**Flood Control Project Maintenance
Levee Inspections
Unit Cover Sheet**

Sutter Maintenance Yard Maintenance Area 0012

Levee Inspection Report By Mile - Spring 2021

Photo 3 of 3 : UCIP_SP_2021_57240_83627.jpg

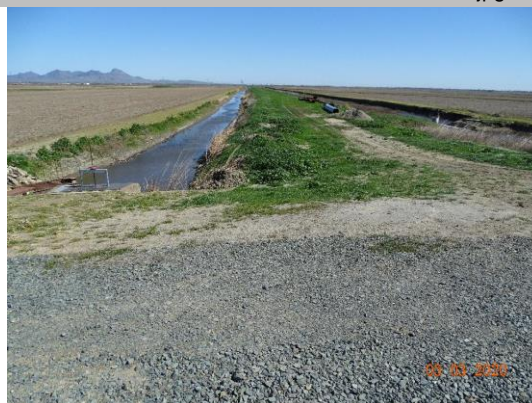
| LM Start | 9.02 | Rating ** | M | Issue No. | 26 (cont) |
